Subject: Braidwood Station Units 1 and 2  
Additional FSAR Information  
NRC Docket Nos. 50-456/457

The Attachment to this letter provides our response to Questions 241.3 and 330.1, and our revised response to Questions 241.5 and 241.7. Our FSAR will be amended to include the information contained in the Attachment to this letter as appropriate. Additionally, mylars of Figures 2.4-2 and 2.4-6, previously sent, have been sent directly to Ms. Janice A. Stevens as requested.

BRAIDWOOD-FSAR

BRAIDWOOD STATION  
FINAL SAFETY ANALYSIS REPORT  
FIGURE Q241.7-5  
LAKE SCREEN HOUSE  
WEST WING WALL

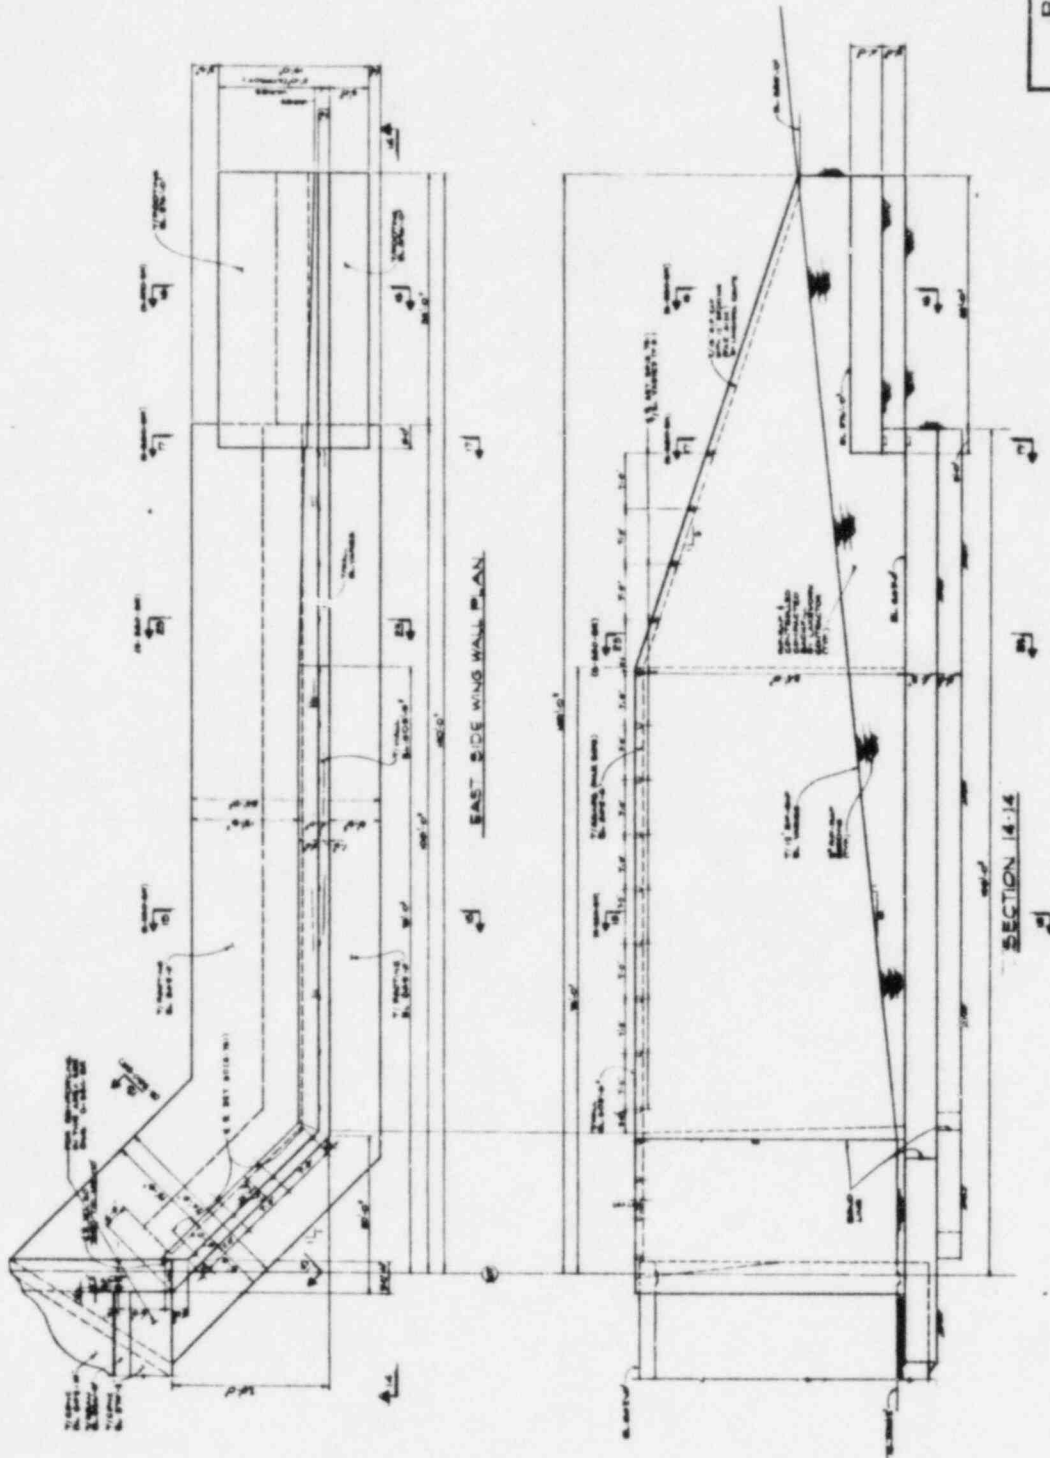
Q241.7 -- The previous response to part 5 of this question referenced figures showing plans and sections of the lake screen house walls, however, these figures were not provided. The plans and sections are given in enclosed Figures Q241.7-5, Q241.7-6, and Q241.7-7.

1. "Ground Motions and Soil Liquefaction During Earthquakes," Seed & Idriss, Earthquake Engineering Research Institute, 1982.
5. There is no Category I sheetpile wall adjoining the lake screen house. The retaining walls adjoining the lake screen house are reinforced concrete wing walls founded on Wedron silty clay till between elevations 561 feet 9 inches and 569 feet 0 inch. The walls are designed as Category I and extend as much as 100 feet east and west of the screen house. Plans and sections of the walls are given in Figures Q241.7-5, Q241.7-6, and Q241.7-7.
